INSTALLATION MANUAL

REF NO.	BT98045A
DATE	Feb. 13, 2002
-	Page 1 of 3

- SUBJECT: INTRODUCTION OF IMPROVED AIR RESERVOIR ON HD325-5, HD325-6, HD405-6, HD255-5
- PURPOSE: To introduce strengthened air reservoir for use on HD325-5, HD325-6, HD405-6 and HD255-5 dump trucks
- APPLICATION: HD325-5 Dump Trucks, Serial Nos. 2001 thru 4293 HD325-6 Dump Trucks, Serial Nos. 5001 and up HD405-6 Dump Trucks, Serial Nos. 1001 and up
 A HD255-5 Dump Trucks, Serial Nos. 1001 and up

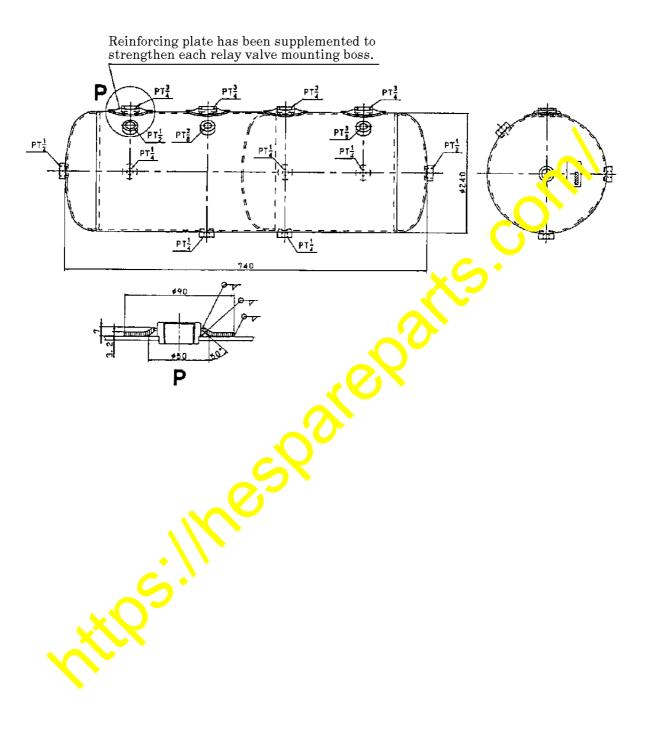
With dump trucks of the above models being use. for hauling and disposing of rock at work sites where blasted rock (of a meter or hove of a side) are loaded onto them without crushing, (especially when the vehicle o dy is not equipped with rubber liners,) loading impact is very high and cracks may o cur in the weld joints of the air-reservoir relay valve mounting bosses.

This Service News introduces estre, gthened air reservoir with reinforced weld portions of the bosses for use on the change trucks being used under these working conditions.

3. Contents of the strengthening modification with the air reservoir Reinforcing plates have been supplemented to strengthen the relay valve mounting bosses.

- 4. Installation procedures
 - 1) Replace the air reservoir 1 with the strengthened air-reservoir.
 - Remove the piping and equipment being connected or installed to the air reservoir and connect them or install them to the new strengthened air reservoir after installing it.
